Fiat Stilo All models

Water penetrating the headlamp.

Cover for right-hand headlamp

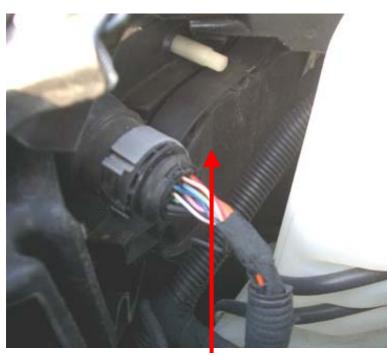
If there are complaints about the formation of condensation in the headlamps, one possible cause is water penetrating the headlamp. In such cases, the complete headlamp(s) do(es) not have to be replaced. Only the rear cover has to be exchanged for a new modified version. Even if the complaint only concerns one of the headlamps,

the change should be carried out on both.
